CITY OF COCONUT CREEK

DEVELOPMENT REVIEW COMMITTEE (DRC) REVIEW #1 – NOVEMBER 13, 2024

PROJECT NAME:	Fifth Third Bank		
PROJECT NUMBER:	PZ-24090007		
LOCATION:	4805 Coconut Creek Parkway		
APPLICANT/AGENT:	BDG Architects		
REVIEW/APPLICATION:	Site Plan		
DISCIPLINE	REVIEWER	EMAIL	TELEPHONE
DRC Chair Urban Design & Development	Liz Aguiar – Assistant Director Sustainable Development	laguiar@coconutcreek.net	(954) 973-6756
Sustainability, Urban Design & Photometrics	Linda Whitman – Sustainability Manager	lwhitman@coconutcreek.net	(954) 973-6756
Urban Design & Signage	Natacha Josiah - Planner	njosiah@coconutcreek.net	(954) 973-6756
Transportation	Michael Righetti - Senior Project Manager	mrighetti@coconutcreek.net	(954) 973-6756
Building	Sean Flanagan – Chief Building Official	sflanagan@coconutcreek.net	(954) 973-6750
Engineering	Eileen Cabrera - Senior Engineer	ecabrera@coconutcreek.net	(954) 973-6786
Fire	Ryan Banyas – Fire Marshal	rbanyas@coconutcreek.net	(954) 956-1563
Landscape	Scott Peavler - Landscape (consultant)	speavler@craventhompson.com	(954) 739-6400

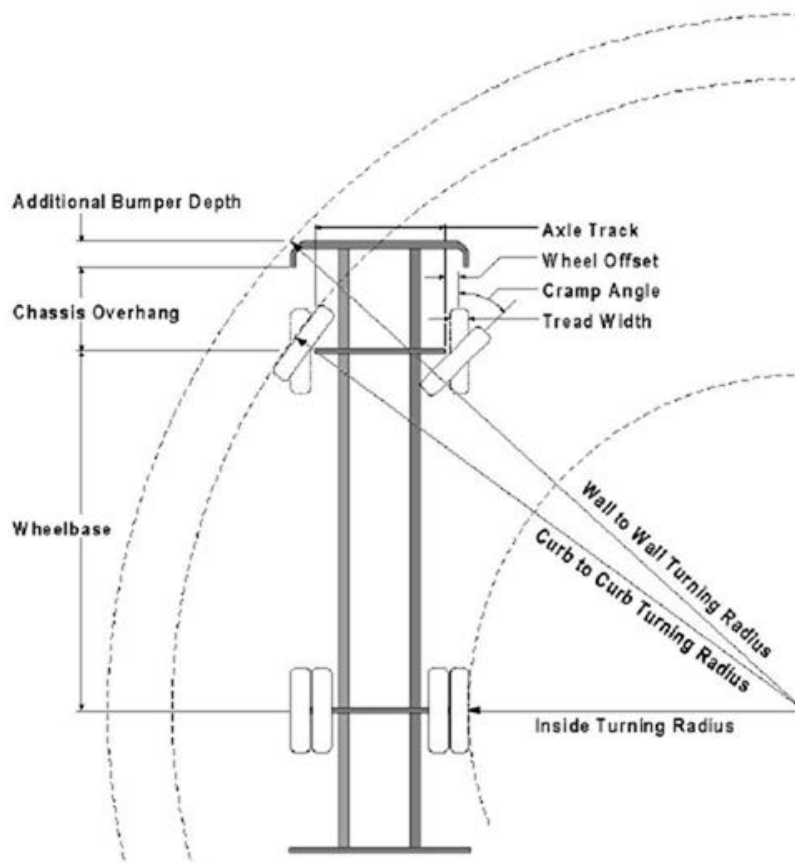
16. Per City Code Sec.13-266, easements shall not contain permanent improvements including but not limited to patios, decks, pools, air conditioners, structures, utility sheds, poles, fences, trees, shrubs, hedges, plants, and landscaping, except that utilities, public improvements and sod are allowed.

Therefore, all trees must be placed outside of any utility easements and not impact any proposed/existing utilities.

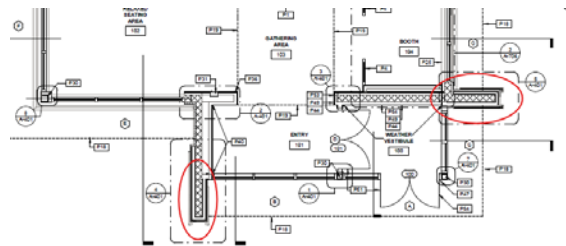
1. Staff understands the state requirements for ATM's and the following comments reflect that understanding.
2. The Photometric plan shall provide footcandle readings at 36" above grade as required by code. Revise plans accordingly.

ATM/night deposit area:

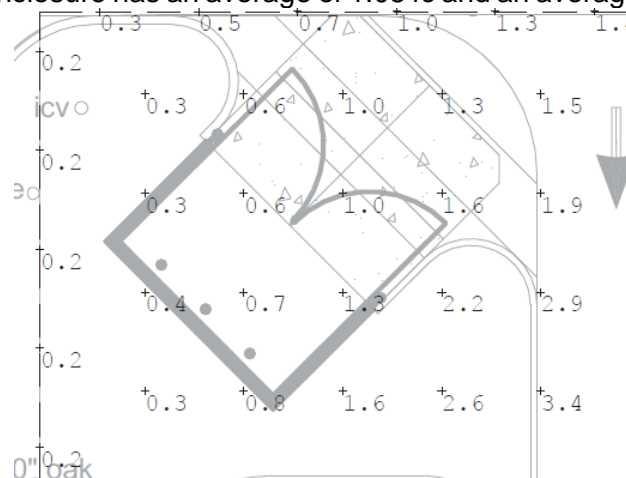
7. Trash enclosures by design are obstructed from casual viewing. As such, they do offer the opportunity to be used as an area of concealment by an abnormal user. Measures should be taken to reduce the desirability of the enclosure to be used for this purpose.
 - o Recommend adding convex mirrors to the rear of trash enclosure to allow a view inside of the enclosure prior to opening the swing gate.
 - o Per IES security lighting guidelines, recommend that trash enclosure be illuminated to an average of 3 fc with an average to minimum ratio of no more than 4:1. Currently, based on readings below, enclosure has an average of 1.05 fc and an average to minimum ratio of 5.25:1.

8. Recommend recessing the drive up ATM into the building attaching the drive up ATM to the building. The current stand-alone design creates an area of concealment directly behind the machine. (If this recommendation is taken, additional review of photometric readings will be needed.)
